ADDENDUM NO. 3

DATE: July 7, 2016

Contract 15-C-00021; Howard F. Curren AWTP HPO Gearbox/Mixer Upgrades and Piping Replacement

Item 2: Replace plan sheets 3, 5 and 6 with the attached plan sheets 3, 5 and 6.

DESIGN DIVISION HEAD
WASTEWATER DEPARTMENT | No. | DATE | REVISIONS | DES: VT
DRN: JHJ
CKD: JF
DATE: 5/2/16 | CITY of TAMPA
WASTEWATER DEPARTMENT | HFC AWTP HPO GEARBOX / MIXER UPGRADES
AND PIPING REPLACEMENT
GENERAL NOTES | 1000417 |

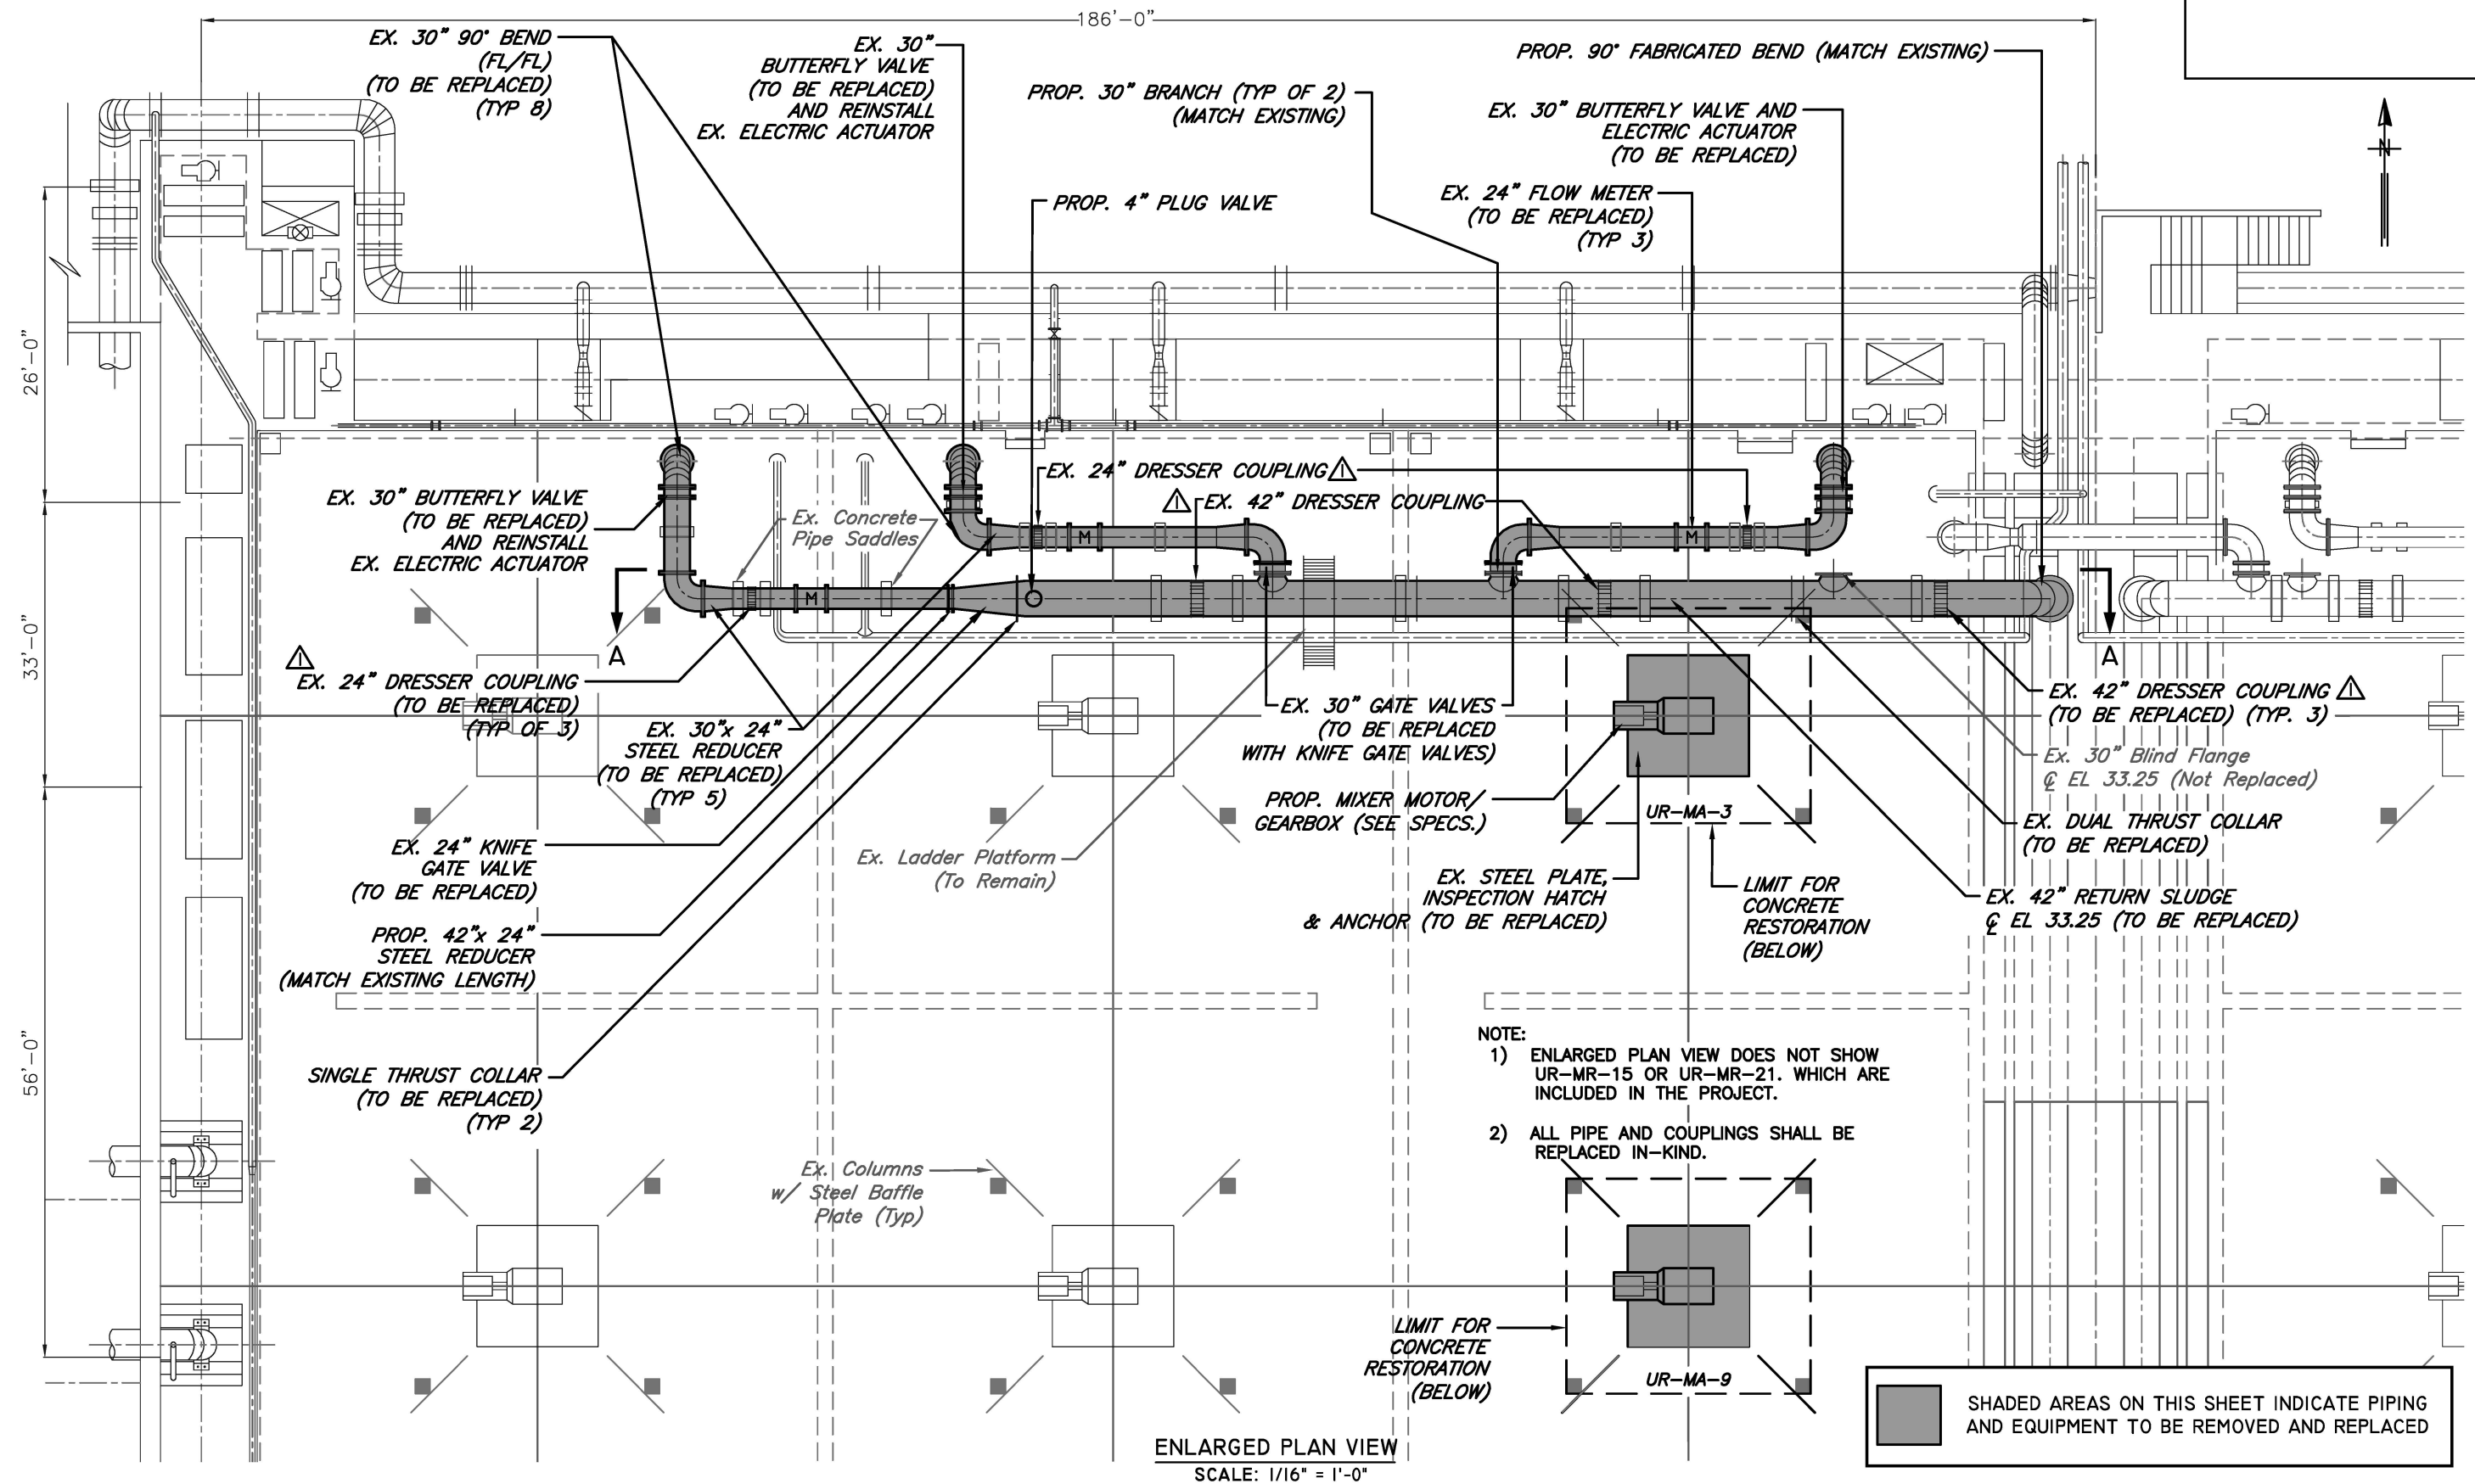
35. ALL SEGMENTS OF RETURN SLUDGE PIPE SHALL BE HYDROSTATIC TESTED AT THE FACTORY. THE TEST PRESSURE SHALL BE 75 PSI.

36. EXISTING WELDED STEEL SUPPORTS SHALL BE REPLACED IN KIND. CONCRETE SUPPORTS TO BE REUSED SHALL BE MODIFIED AS NECESSARY TO SUIT NEW PIPE INSTALLATION. SINGLE AND DUAL THRUST COLLARS SHALL BE REPLACED IN KIND.

| | 1 | 7/6/16 | ADDENDUM 3 ADD NOTE | | | | |

HFC AWTP HPO GEARBOX / MIXER UPGRADES
AND PIPING REPLACEMENT
ENLARGED PLAN VIEW

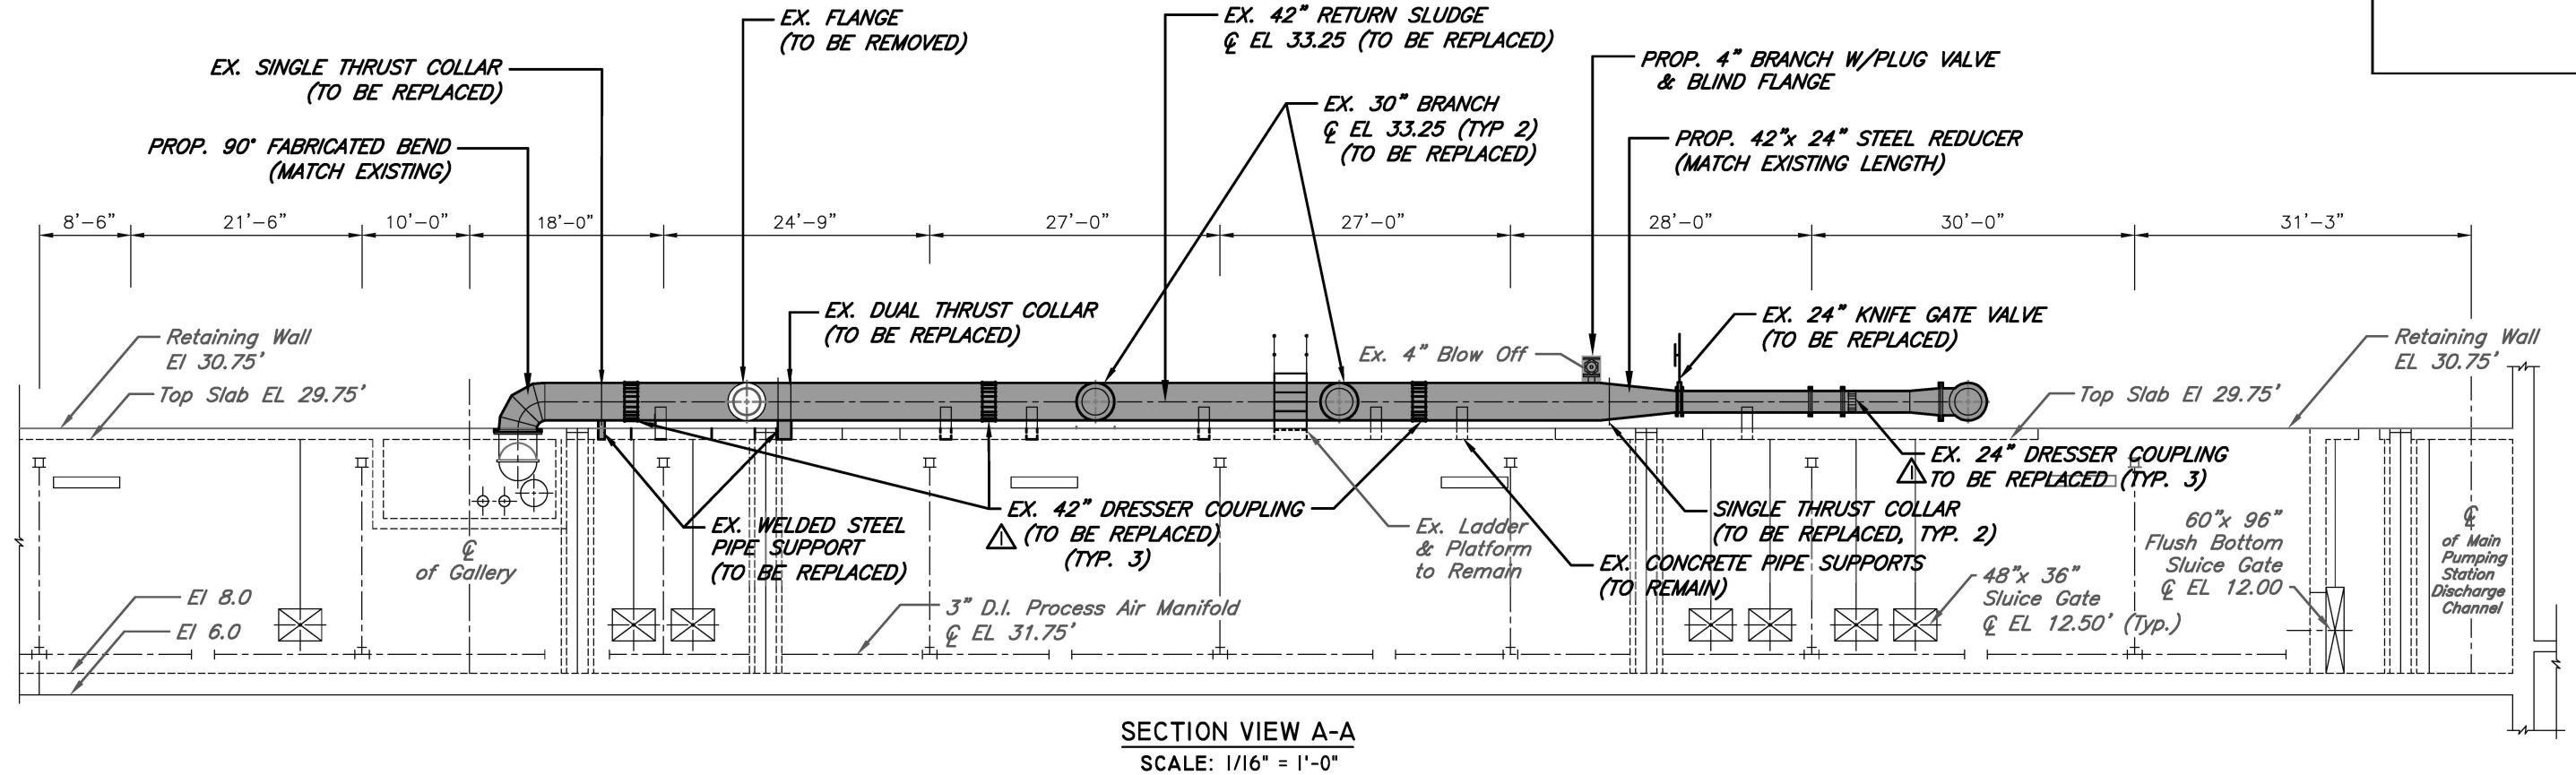
No.	DATE	REVISIONS
3		
2		
△	7/6/16	ADDENDUM 3 ADD NOTE

HFC AWTP HPO GEARBOX / MIXER UPGRADES
AND PIPING REPLACEMENT
PROPOSED SECTION VIEW

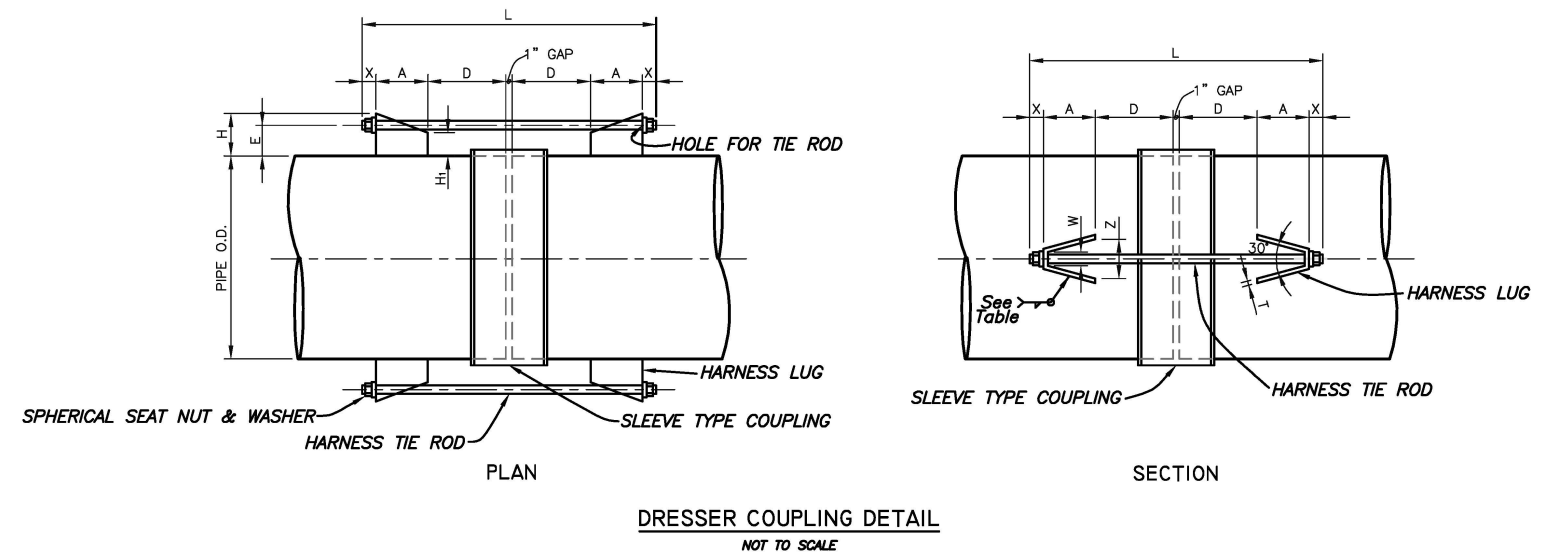
No.	DATE	REVISIONS
3		
2		
1	7/6/16	ADDENDUM 3 ADD NOTE
